CRUISER AIRCRAFT	<h1>SERVICE BULLETIN</h1>	Czech Aircraft Group s.r.o. Na Záhonech 212 686 04 Kunovice Czech Republic info@cruiseraircraft.com
		No. SB-CR-033
		Date: 2016-03-18
		Page: 1 of 10
		Rev.: 1
		Date: 2021-01-28

MODEL AFFECTED:	PS-28 Cruiser SportCruiser / PiperSport - under EASA PtF operation only
SUBJECT:	Change from Cylinder Head Temperature to Coolant Temperature measurement method for aircraft equipped with Rotax 912 ULS and 912 S2 series engine with a new cylinder head design.
AIRCRAFT AFFECTED:	PS-28 Cruiser up to S/N C0556 including SportCruiser – all S/N PiperSport – all S/N
COMPLIANCE:	As per EASA AD 2015-0240 (for Rotax engines)

Figure 3 - Difference between old and new cylinder head design and temperature sensor position

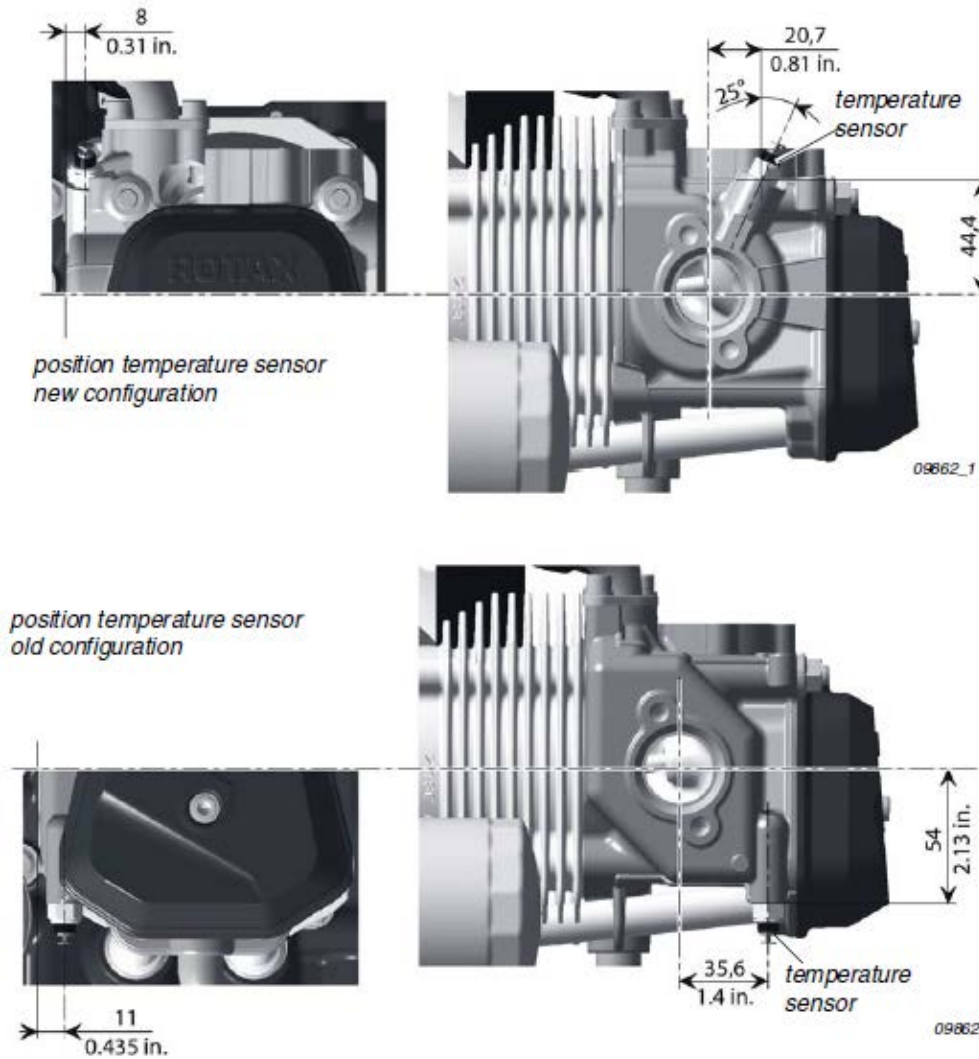
With the change to a new cylinder heads design (P/N 413185 at cylinder head position 2/3) no longer the Cylinder Head Temperature is measured, but the Coolant Temperature.

The measuring position of the temperature sensor has changed. With this new installation position of the temperature sensor, a loss of coolant can be recognized easily. The change to the new cylinder heads does not affect the cooling capacity.

- c) To recognize the **difference between the old and new cylinder head design and the temperature sensor position**, see Figure 3.

Figure 4 Check of the engine serial number S/N and the suffix -01 on the type plate. (see the whole SB-912-068 R1 from ROTAX for details)

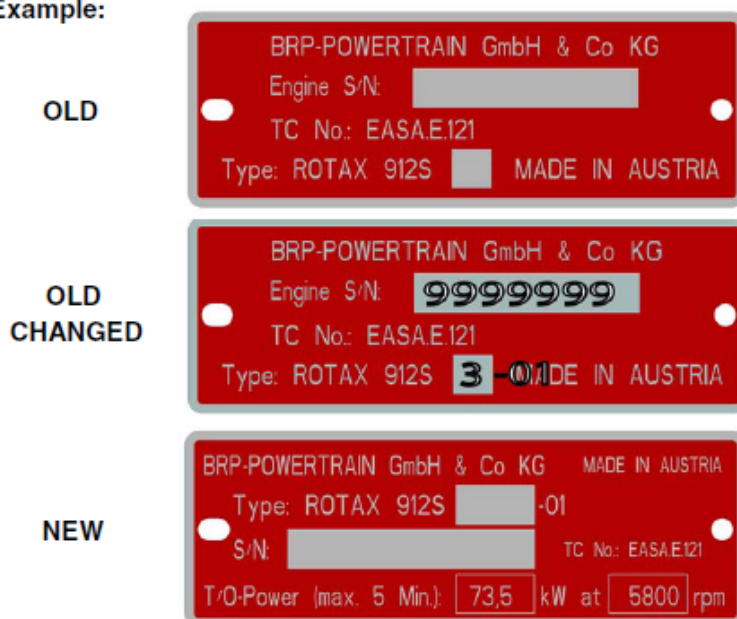
5. In case the **new cylinder heads design** (P/N 413185 at the cylinder head position 2/3) **is found**, check if the suffix-01 on the type plate is present, see Figure 4 below. If the suffix-01 on the type plate is not present, ensure a permanent application of the suffix -01 (e.g. engraved, stamped or similar), see Figure 4.
Note: In case there is only one cylinder head of the new type (P/N 413185) at a single position 2 or 3 installed, ensure at authorized service organization that the cylinder head of the old type on the other position (2 or 3, as applicable) be replaced with a new type of the cylinder head having P/N 413185.
Any changes regarding to this Service Bulletin must be confirmed in the logbook

Step	Procedure
1	Apply suffix - 01 permanently (e.g. engraved, stamped or similar) to the type plate. NOTE: Any changes regarding to this Service Bulletin must be confirmed in the engine logbook.

Figure 5 - extension of the air cooler inlet hole in the engine bottom cowling

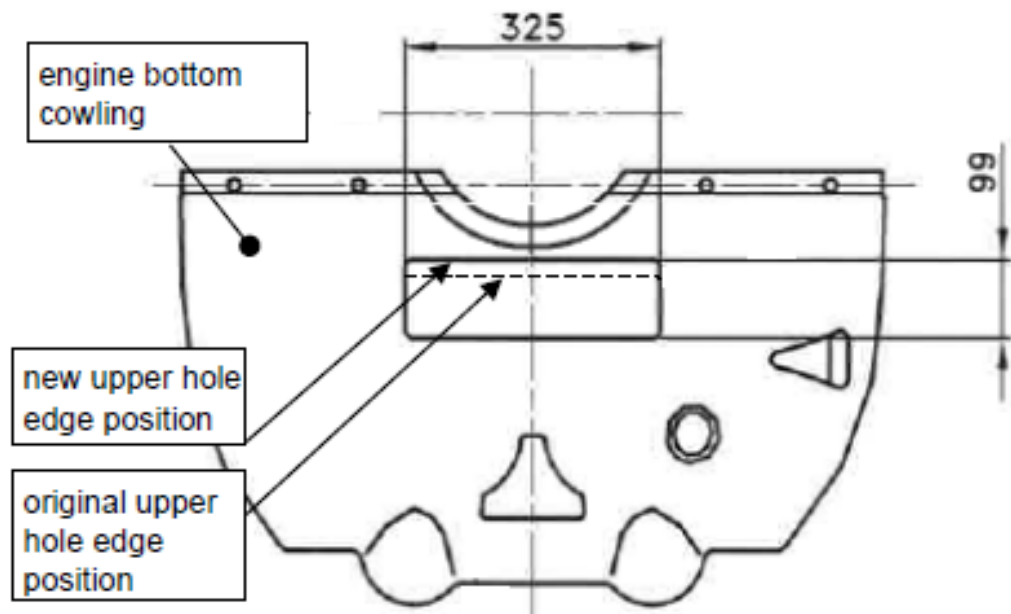
Due to these changes the Coolant Temperature (CT) instead of the Cylinder Head Temperature (CHT) in the aluminium is displayed. For that reason it is necessary to check/correct the Coolant Temperature limit (120°C) displayed on the instrument panel, check/correct its naming (CT instead of CHT). To improve the engine cooling characteristics, an extension of the air cooler inlet hole in the engine bottom cowling is to be applied.

10. Extension of the air cooler inlet hole in the original engine bottom cowling.

- 10.1. Use the engine bottom cowling, measure out and mark new hole top edge acc. to the Figure 5 below. The new top edge is moved upwards.
- 10.2. Cut off the top rim accordingly to the marking and clean the hole.
- 10.3. Fit in place and adjust the cut off top rim and laminate it back in the extended cowling inlet hole.
- 10.4. Use an additional fiberglass and apply for laminating of side parts of the cowling hole.
- 10.5. Carry out sanding for good adhesion of the repair coats.
- 10.6. Apply a sufficient primer and top coat to restore the original colour design of the surface.
